Circular

China Classification Society
（2010） Circ. no. 28 Total no.28
06/01/2010 (Total of 177 pages)

Notice on Common Structural Rules for Double Hull Oil Tankers, July 2008: Rule Change Notice No.2, April 2010 and Common Structural Rules for Bulk Carries July 2008: Rule Change Notice No.2, April 2010

Rule Change Notice No. 2
April 2010

Table 1: Alignment (t, t_1 and t_2: as-built thickness)

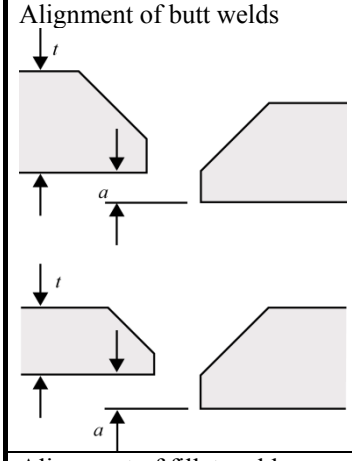
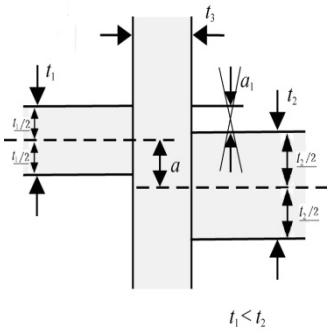
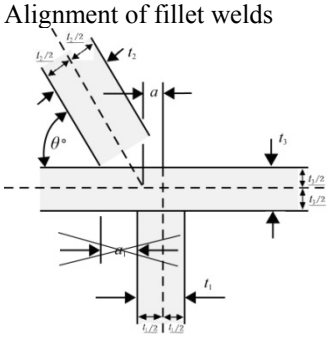
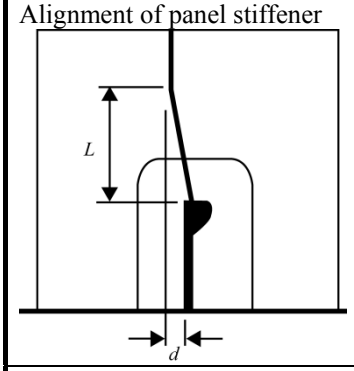
Detail	Standard	Limit	Remarks
Alignment of butt welds 	~~a ≤ 0.15t strength~~ ~~a ≤ 0.2t other~~	~~a ≤ 3.0 mm~~ $a \leq 0.15t$ strength member $a \leq 0.2t$ other but maximum 4.0 mm	t is the lesser plate thickness
Alignment of fillet welds 	~~a) Strength and higher tensile steel~~ ~~$a \leq t_1$ / 4 measured on the median~~ ~~$a \leq (5t_1 - 3t_2) / 6$ measured on the heel line~~ ~~b) Other~~ ~~$a \leq t_1$ / 2 measured on the median~~ ~~$a \leq (2t_1 - t_2) / 2$ measured on the heel line~~	Strength member and higher stress member: $a \leq t_1/3$ Other: $a \leq t_1/2$	Alternatively, heel line can be used to check the alignment. Where ~~t_2~~ t_3 is less than t_1, then ~~t_2~~ t_3 should be substituted for t_1.
Alignment of fillet welds 	~~a) Strength and higher tensile steel~~ ~~$a \leq t_1$ / 3 measured on the median~~ ~~b) Other~~ ~~$a \leq t_1$ / 2 measured on the heel line~~	Strength member and higher stress member: $a \leq t_1/3$ Other: $a \leq t_1/2$	Alternatively, heel line can be used to check the alignment. Where t_3 is less than t_1, then t_3 should be substitute for t_1.

Figure 2: Example of mass curve for BC-A ships having {No MP} assigned

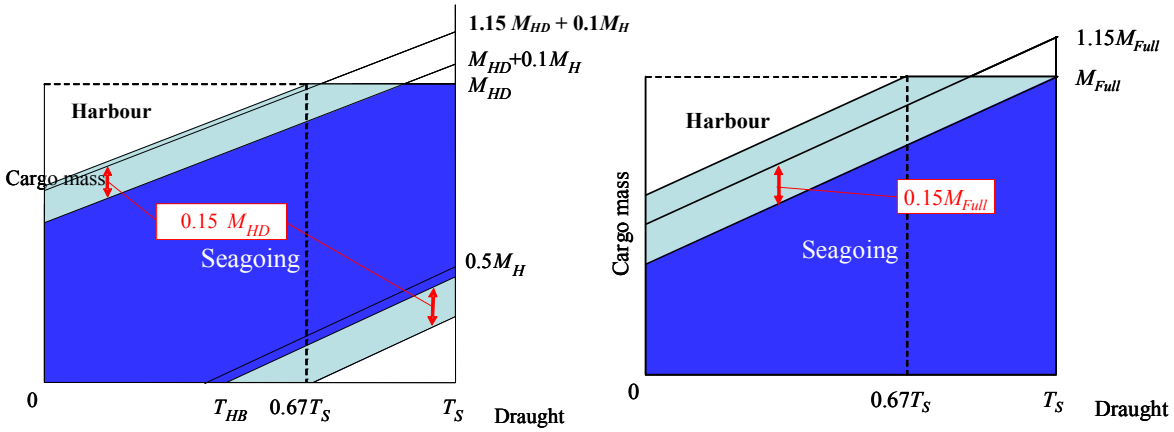
~~The maximum permissible mass ($W_{max}(T_i)$) and the minimum required mass ($W_{min}(T_i)$) at various draughts (T_i) are the same specified in [2.1.2].~~

The maximum permissible mass ($W_{max}(T_i)$) at various draughts (T_i) is obtained, in t, by the following formulae:

$$W_{max}(T_i) = M_{Full} - 1.025 V_H \frac{(T_S - T_i)}{h}$$

Figure ~~2~~ 4: ~~Example of mass curve for BC-B or BC-C ships~~ Example of mass curve for BC-B and BC-C ships having {No MP} assigned

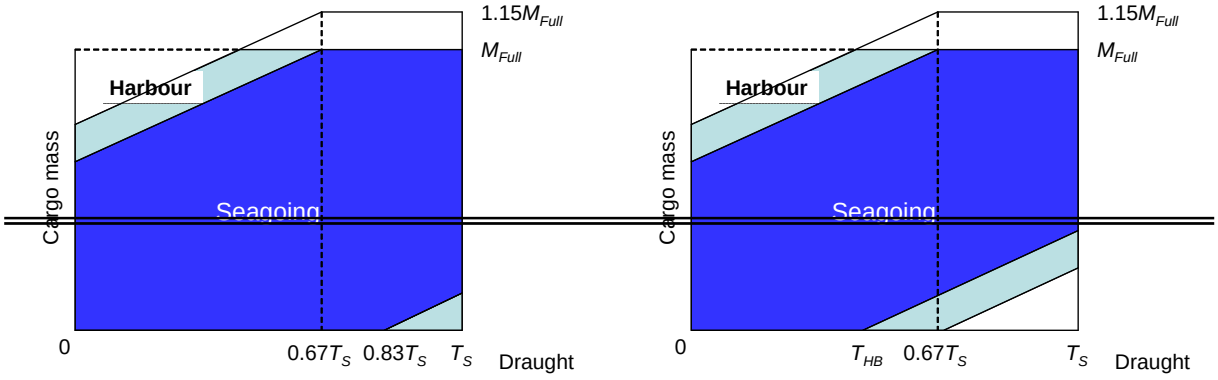
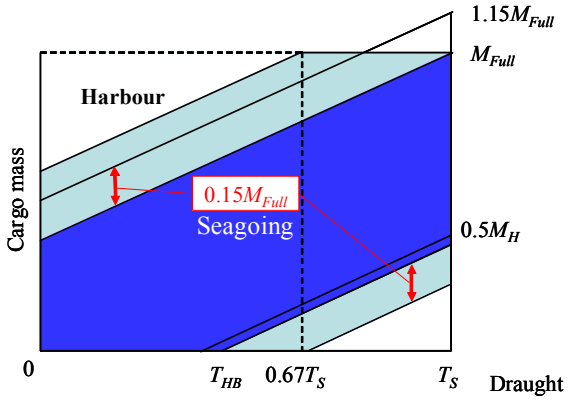
Example~~s~~ for mass curve of cargo hold for **BC-B** or **BC-C** ships with {No MP} ~~are~~is shown in Fig ~~2~~4.

Figure 3: ~~Example of mass curve for BC-B or BC-C ships~~

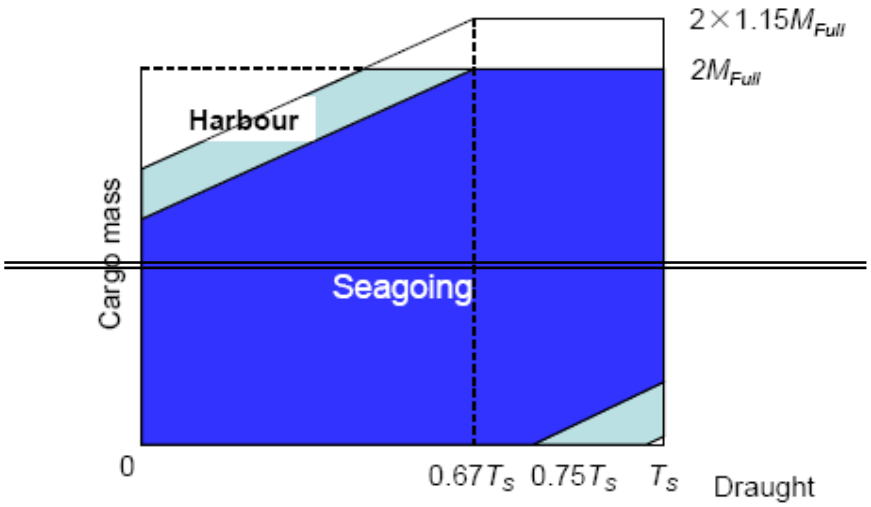
~~$W_{\min}(T_i) = 0$ for $T_i \le 0.75T_S$~~

~~$W_{\min}(T_i) = 1.025(V_f + V_a)\frac{T_i - 0.75T_S}{h}$ for $T_S \ge T_i > 0.75T_S$~~

(void)

Figure 4.3.4
Collars for Cut-outs in Areas of High Stress

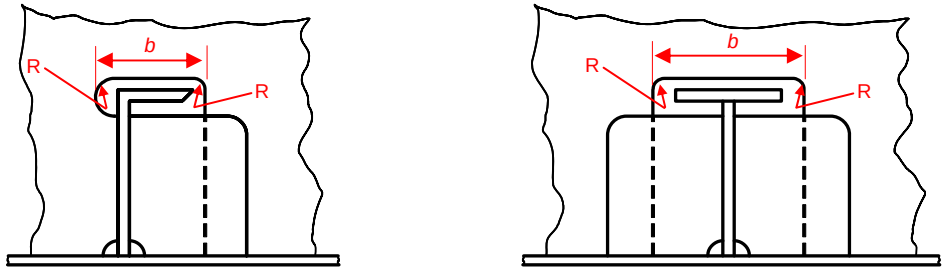
3.4.2.1 ~~Cut outs~~ In general, cut-outs are to have rounded corners and the corner radii, *R*, are to be as large as practicable, with a minimum of 20 percent of the breadth, *b*, of the cut-out or 25mm, whichever is greater, but need not be greater than 50mm, see *Figure 4.3.4*. Consideration will be given to other shapes on the basis of maintaining equivalent strength and minimizing stress concentration.

The Rule text is proposed amended to clarify the requirements for cut-outs.

Figure C.2.2
Hopper Knuckle Connection Detail, Without Bracket

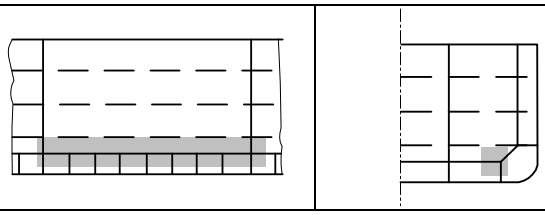
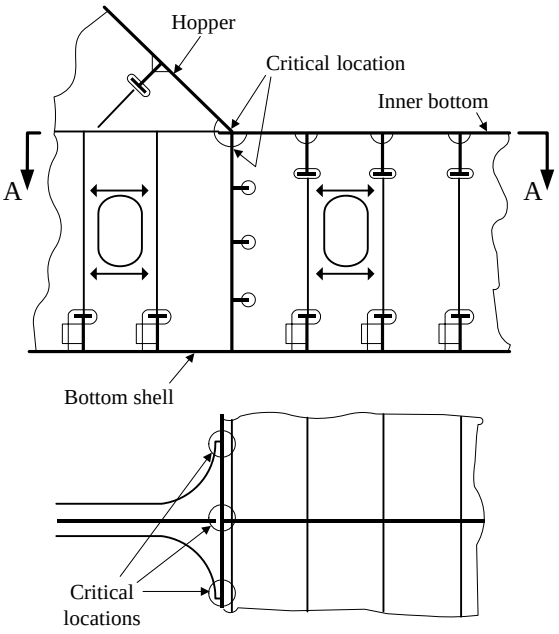
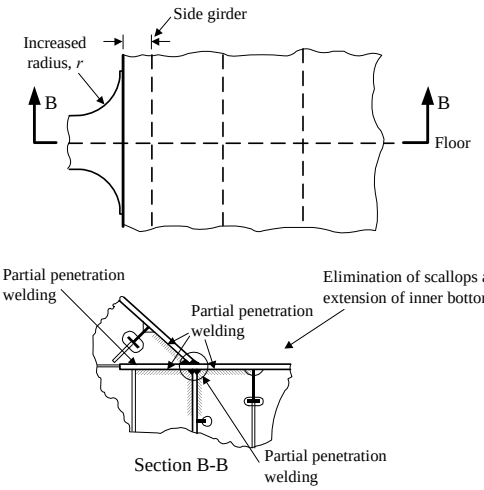
Weld between hopper plating and inner bottom plating to be ~~dressed~~ extended and ground smooth. Visible undercuts are to be removed.
Weld extension and grinding to be applied 200 mm either side of the floor.

(1) It is requested to clarify the "dressed" and "ground smooth" which are stated in Figure C2.2 of Appendix C and to specify in the detailed procedure of such improvement measure.

(2) In the Figure C2.2 of Appendix C, extent of dressing both side of floor.

Figure C.2.3
Option: Hopper Knuckle Connection Detail, With Bracket

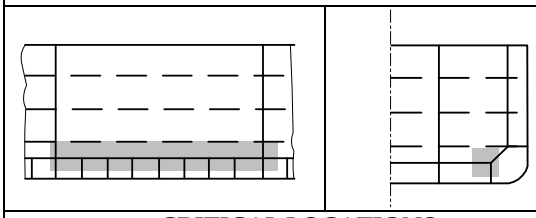
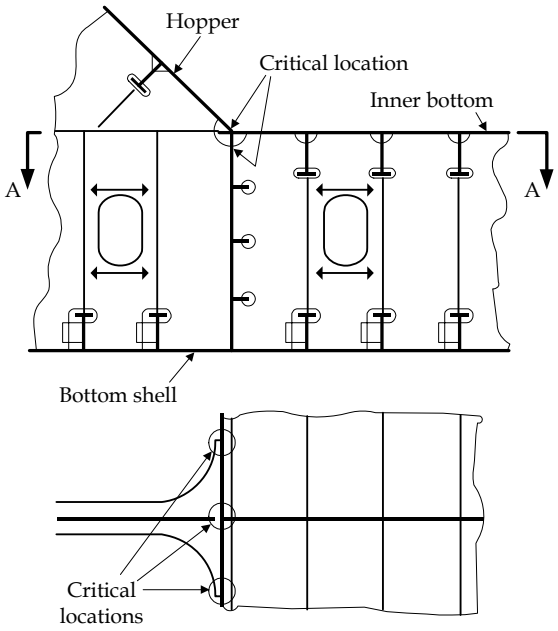
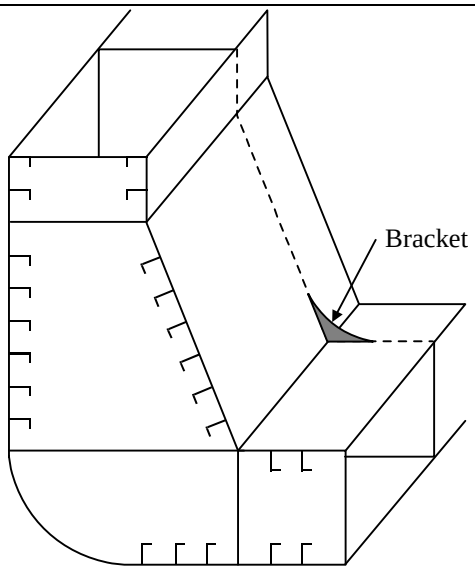
Stripe coating is stipulated where weld toe grinding is applied in order to protect the ground surface from corrosion. This is not relevant to Fig.C.2.3 where a bracket is fitted in lieu of weld toe grinding. The sentence was retained by accident when copying from one figure to another during rule development.

Figure 1: Coefficients C_1 and C_{m1} for corrugated transverse bulkheads without bottom stools

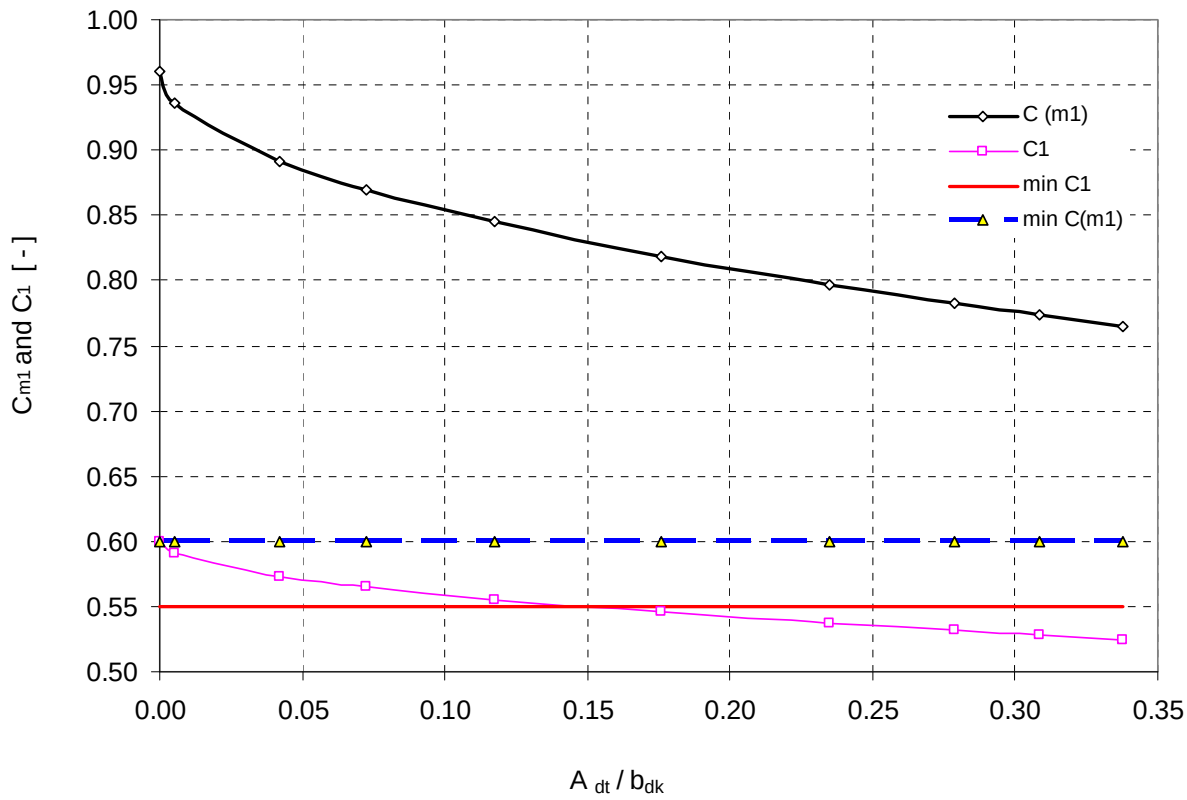
The new formulae for corrugated bulkheads without bottom stools were derived from the formulae for corrugated bulkheads with bottom stools and deck boxes. After the coefficients C_i (for the lower end and mid-span of transverse and longitudinal bulkheads) were calculated for numerous values of the parameter R_b (bottom stool parameter) within the wide range of the selected A_d/b_d ratio, analytical equations for the coefficients C_i as a function of the parameter R_b have been developed. Now, a corresponding value of C_i using the analytical equations can be obtained when R_b is 0 (i.e. no bottom stool exists). Then from the derived values of C_i for case when R_b=0, the corresponding curves for C_1, C_{m1}, C_3 and C_{m3}

as a function of the ratio A_d/b_d were built for transverse and longitudinal bulkheads. The proposed equations correspond to those curves in a smooth form.

The proposal is to amend the Rules to have prescriptive requirements for bulkheads without lower stools.
